Amendment No. 45

Bundle Average Exposure (MWD/MT)
ANF 8x8 Reload Fuel
Maximum Average Planar Linear Heat
Generation Rate (MAPLHGR) Versus
Bundle Average Exposure

Figure 3.2.1-3

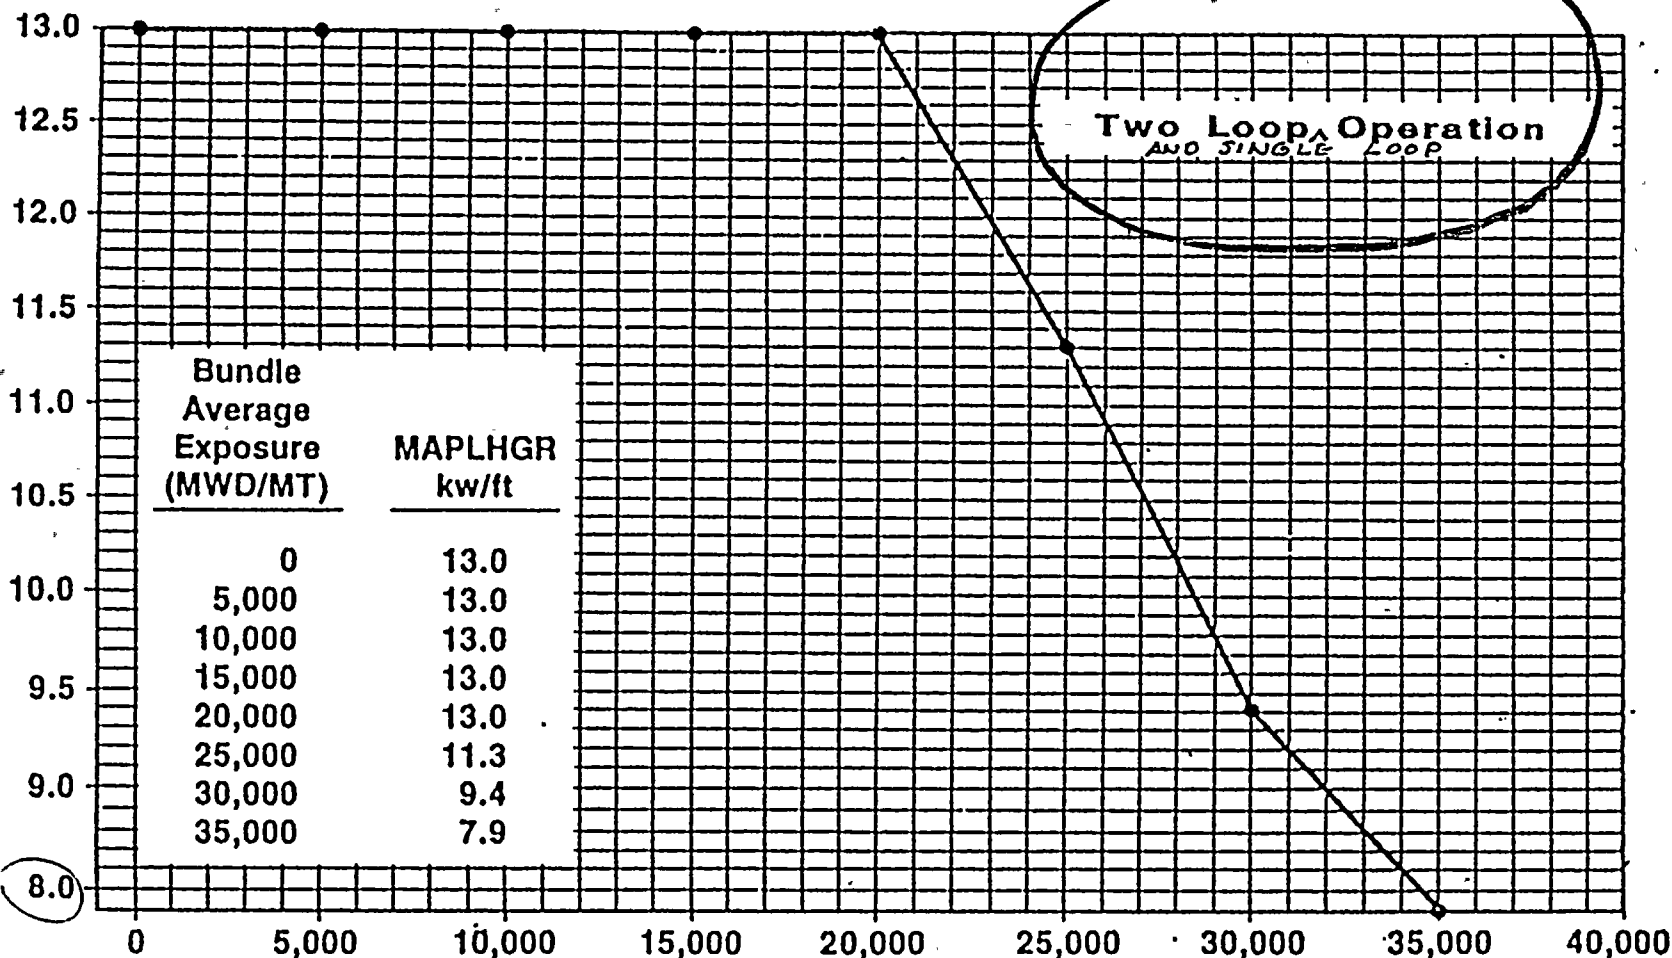
ADD

Operating Region
 Thermal Power Limits of Specification ~~3.2.6-1~~ ^{3.2.6}
 Figure ~~3.2.6-1~~ ^{3.2.6-1}

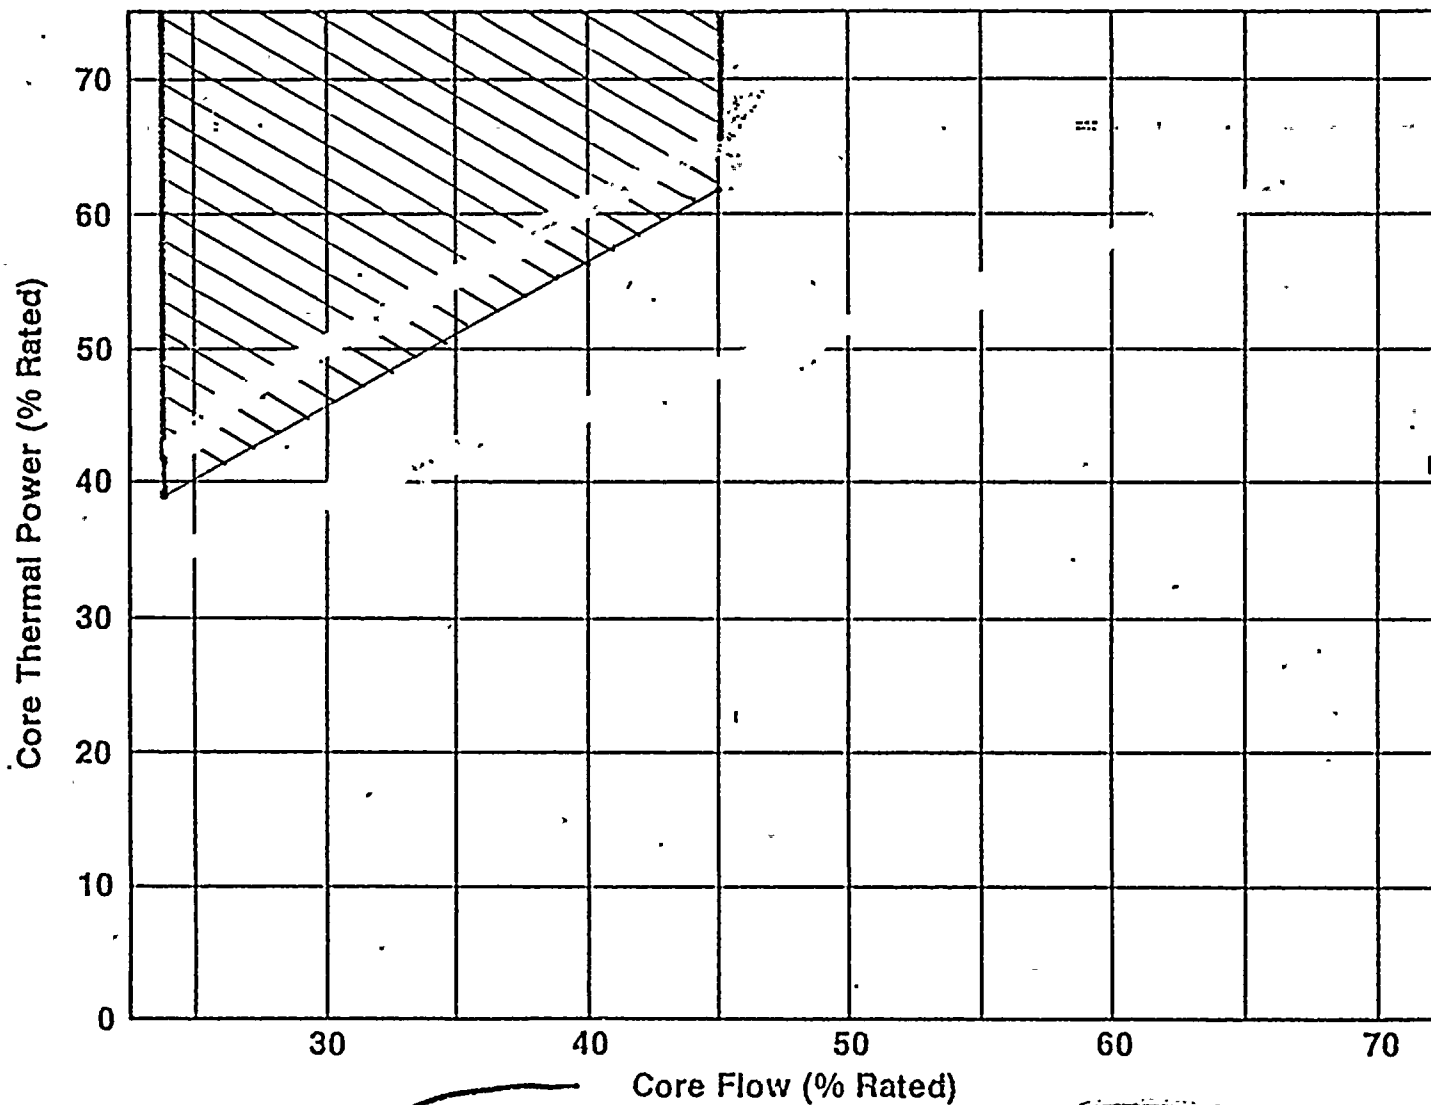
ADD
